Agenda Item Transmittal

Agenda Title: Discuss and consider action on Site and NPS plans for the Pearl Multifamily development located at 13400 Bee Cave Parkway, Bee Cave, TX including the following plans:

**The Pearl
Bee Cave, Texas**

Re: Morgan (Applicant) Responses to P&Z Question

BUILDING 2 &
BUILDING 3 -
BUILDING
ELEVATIONS

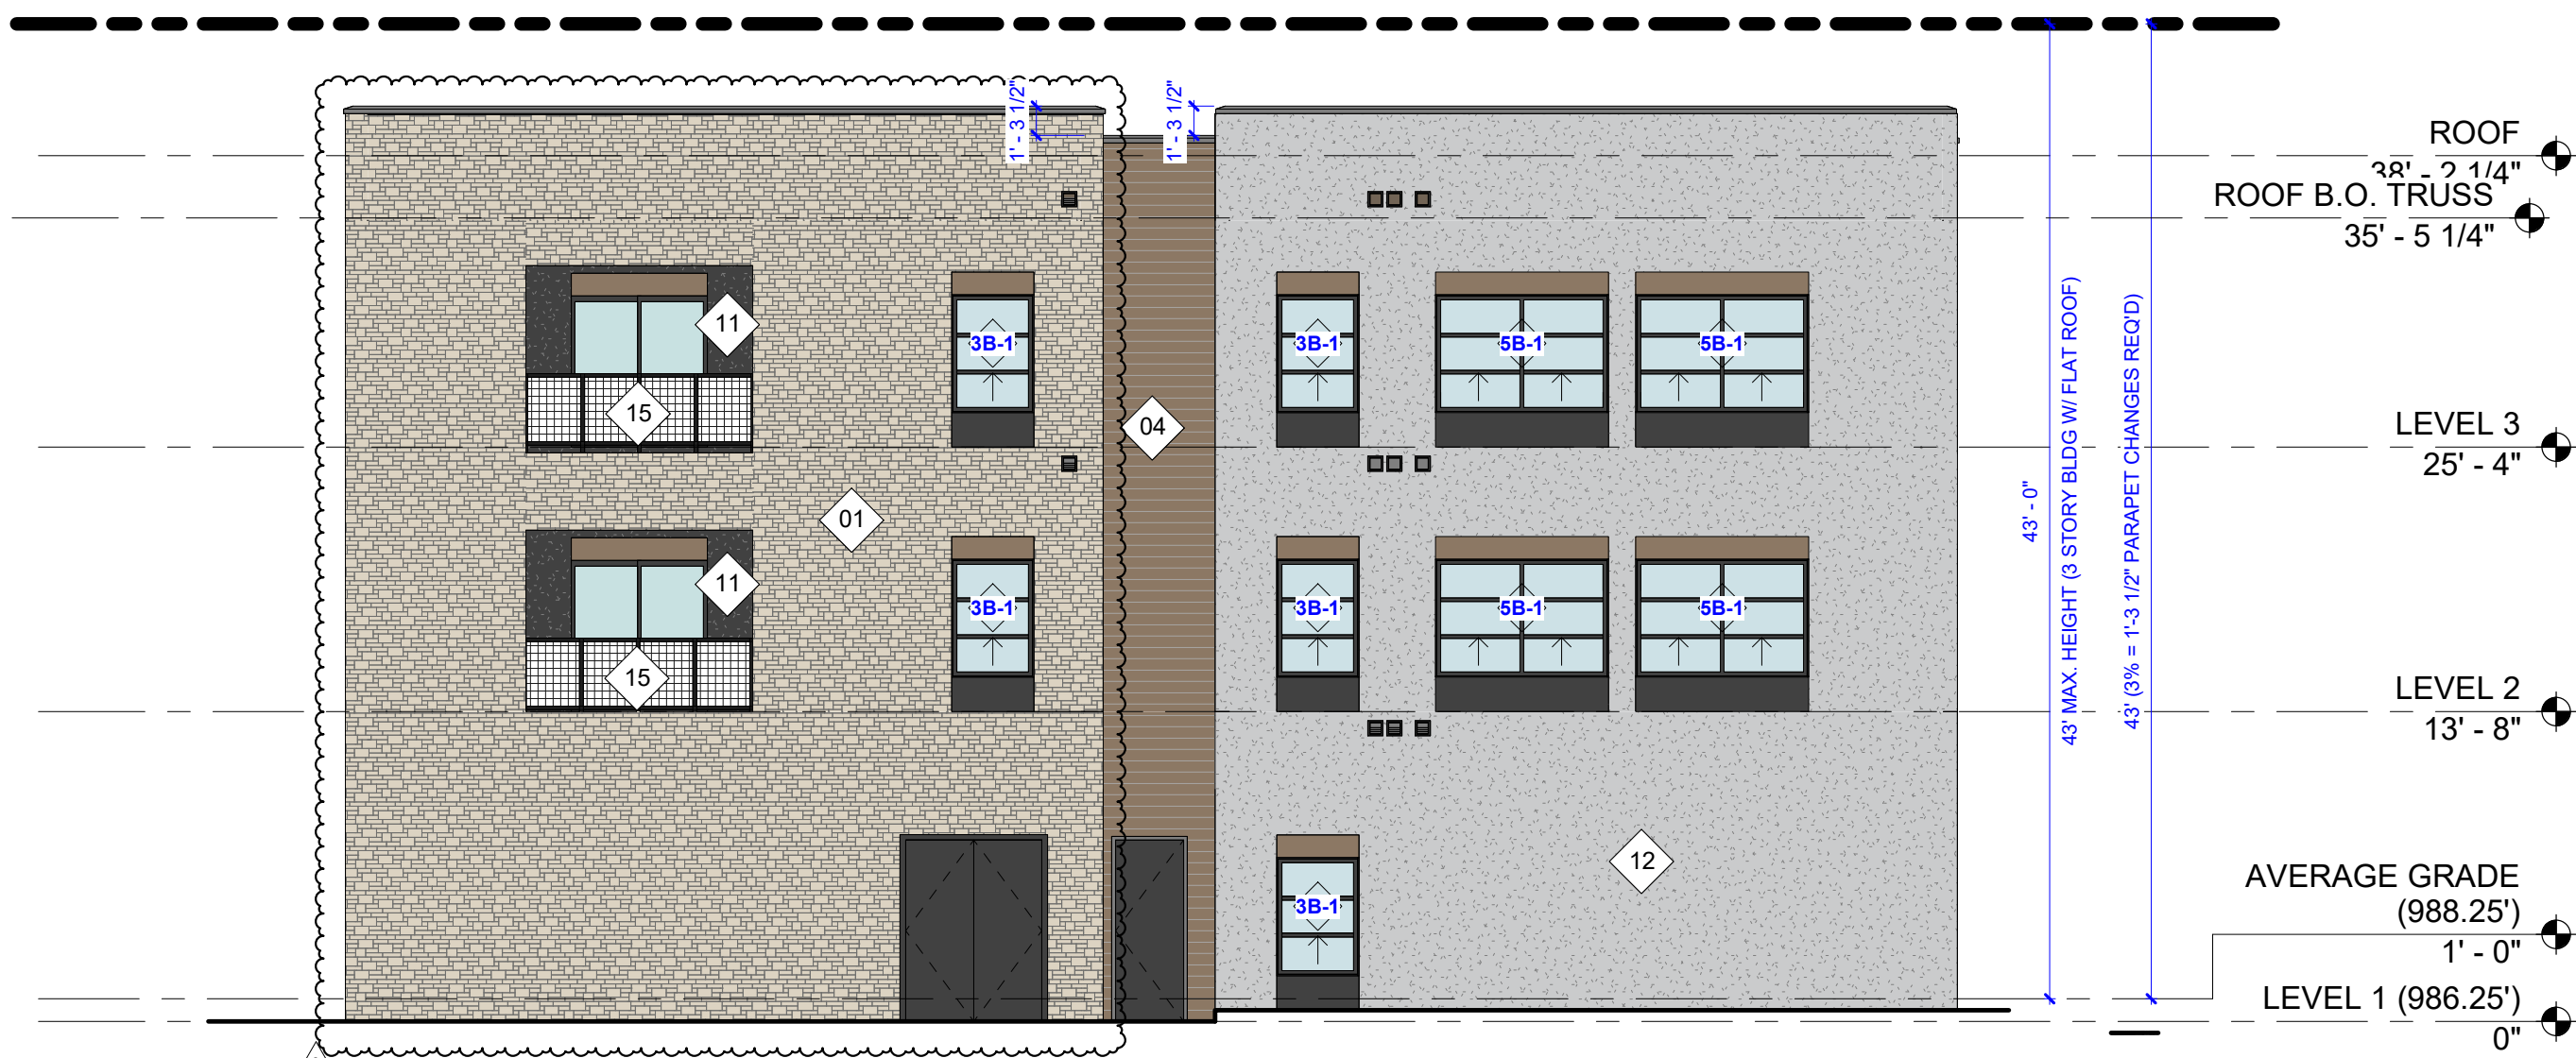
2. Confirm building height compliance related to 3-story buildings with flat roofs being a maximum of 43' or less and 4-story being 53' or less. The applicant has made adjustments to the architectural elevations as detailed in the attached report to ensure compliance.

The elevation exhibits presented at P&Z on 8/1/23 measured the building heights of each building from the lowest level of elevation adjacent to the building. This resulted in each building showing a non-conforming height. Morgan and the project architect recalculated the heights of each building taking into account the average grade rather than the lowest grade. This analysis revealed minor overages for certain parapets, trellises, and canopies.

The noted overages have since been reconciled via minor adjustments to the architectural elevations in order to comply with the maximum height stated for 3- and 4-story buildings. All building roof configurations are flat and compliance is demonstrated in the following exhibits.

**BUILDING 2
AFTER MODIFICATION**

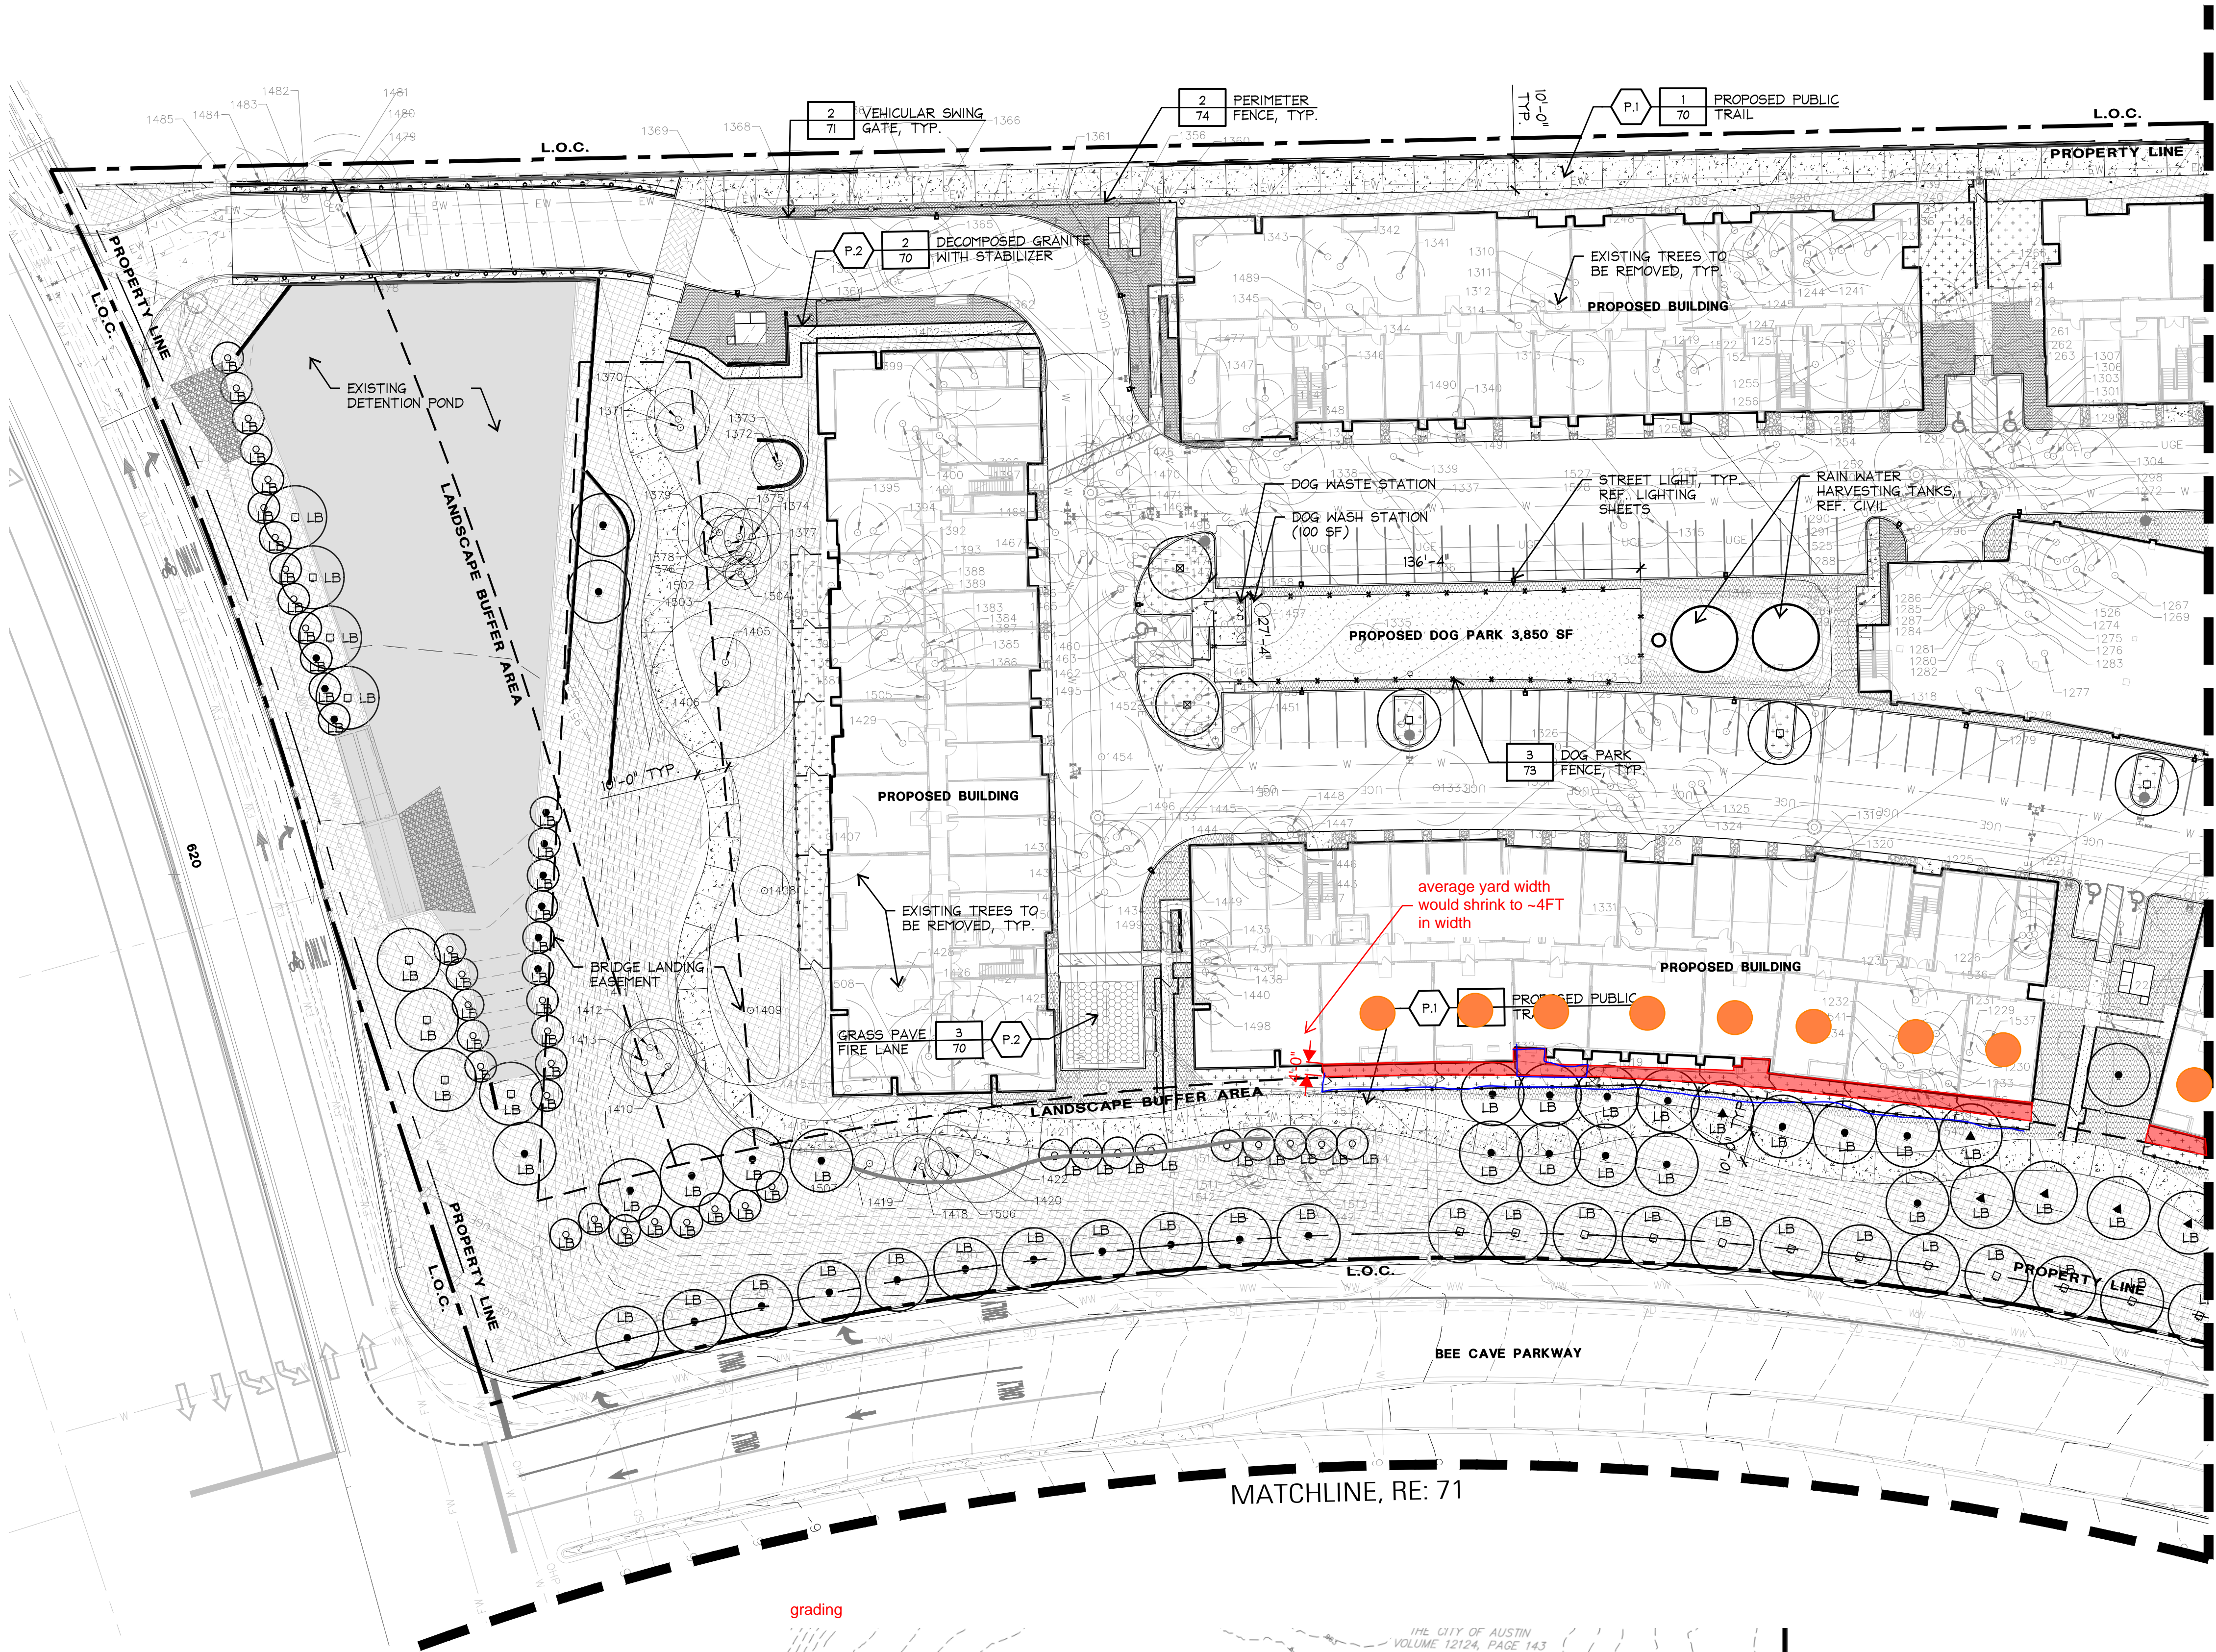
3. Ground Floor Private Yard Compliance with fencing located in the front yard setback. Please see attached consultant report for explanation.
4. Garage architectural elevations are provided in the attached report. The applicant has also provided a photometric study to confirm compliance with Section E Lighting of the PDD as it relates to the parking garage:

Per the PDD, at least 50% of ground floor units must have private, fenced yards comprising a minimum of 75 square feet. As currently designed, The Pearl features 64 ground floor units, of which 33 units have private, fenced yards, which results in 51.6% of the ground floor units. Yard fences are 3'6" tall comprised of 14-gauge tube metal frame with 4" square welded wire steel mesh.

Morgan and city staff reviewed all yard configurations and areas to ensure compliance with the PDD. Per Section VI, Subsection H(4) of Exhibit C of the PDD, "fences are permitted within the building setbacks." Subsection J6 was not intended to apply to private yard fences, and clarifies design requirements for the property boundary fence.

Morgan and city staff interpret the current private yard design to fully comply with the applicable portions of the PDD. Additionally, the 3'6" height of the private fences will be well concealed behind the enhanced landscaping & vegetative buffer and the decorative hedges planted between the fences and the 10' public loop trail – as seen in the below illustration.

illustrative landscape sections
@ Bee Cave Parkway

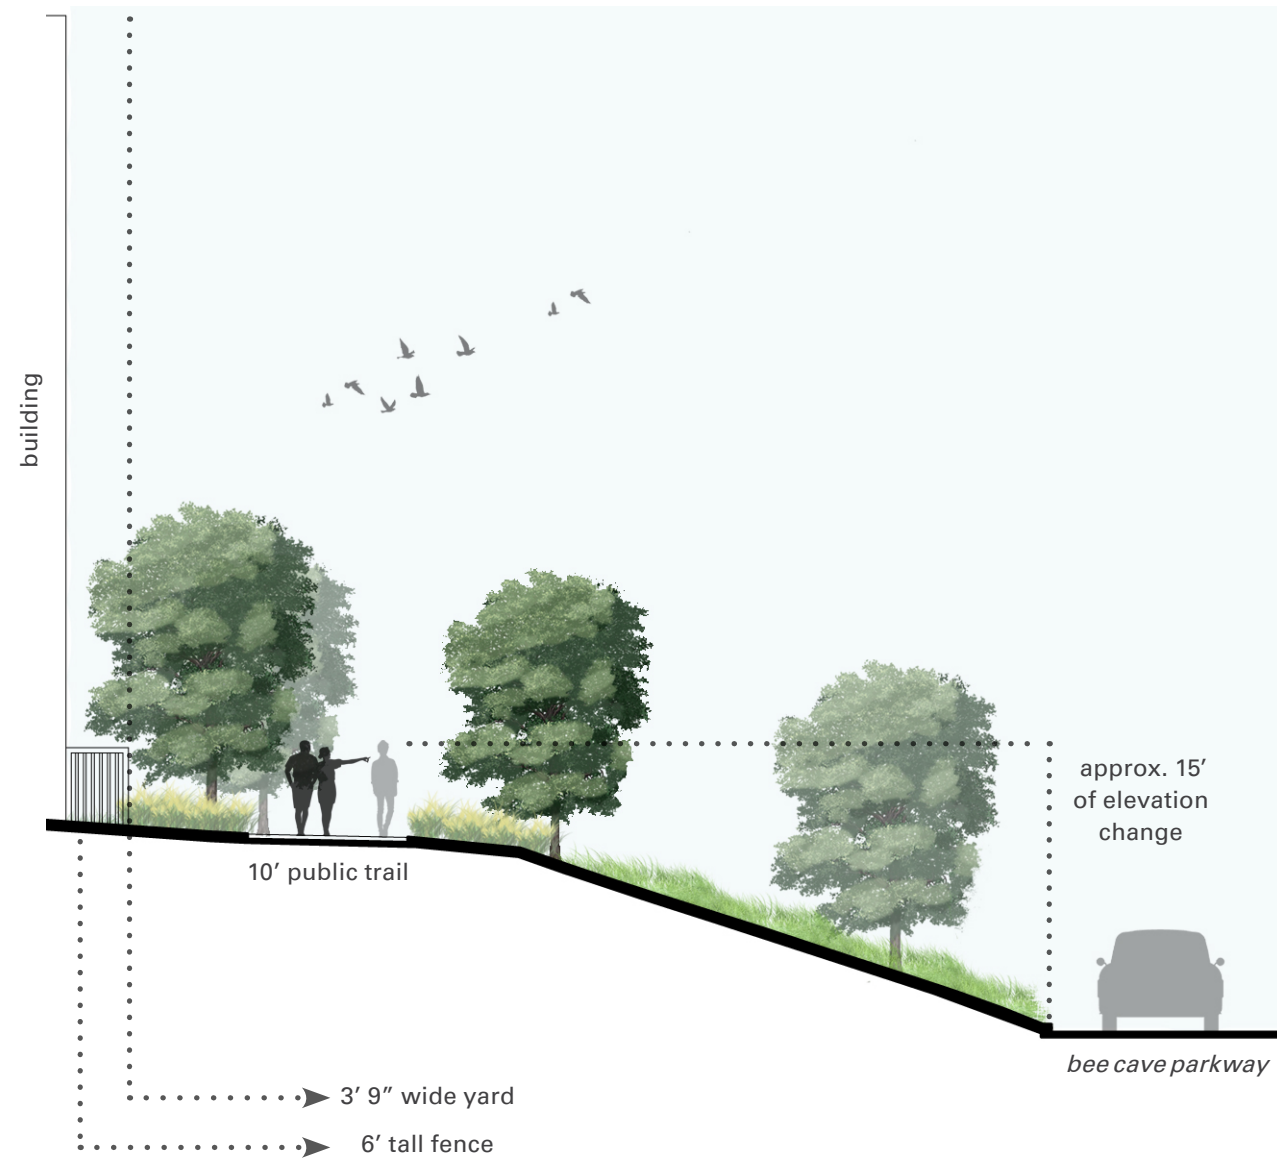
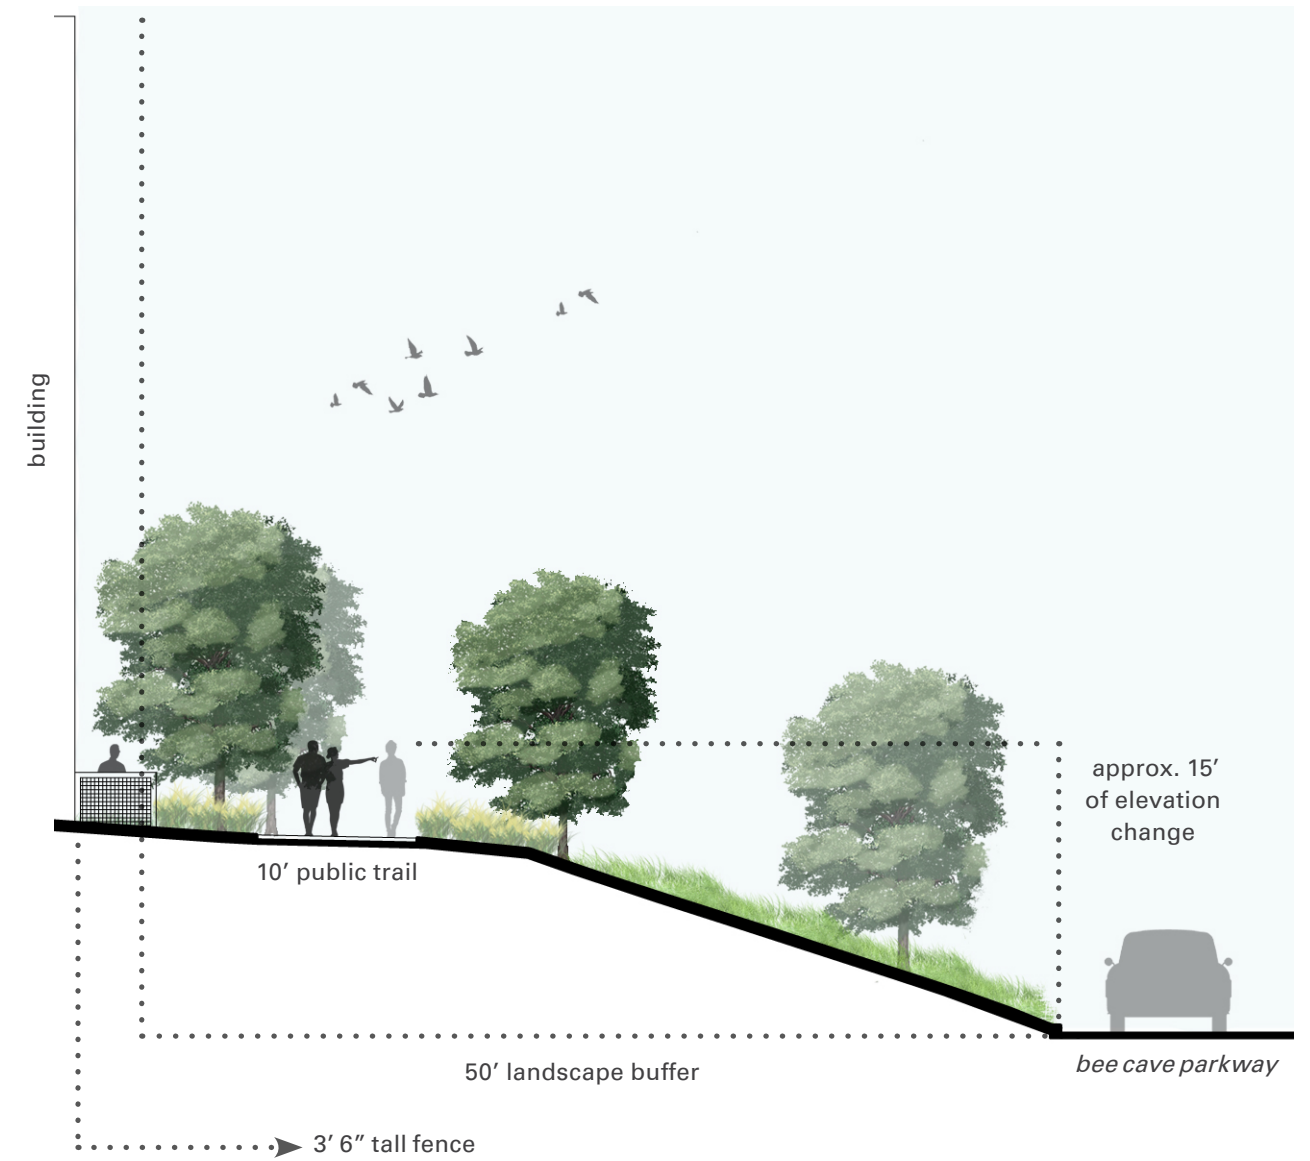
a. P&Z Comment

b. proposed condition
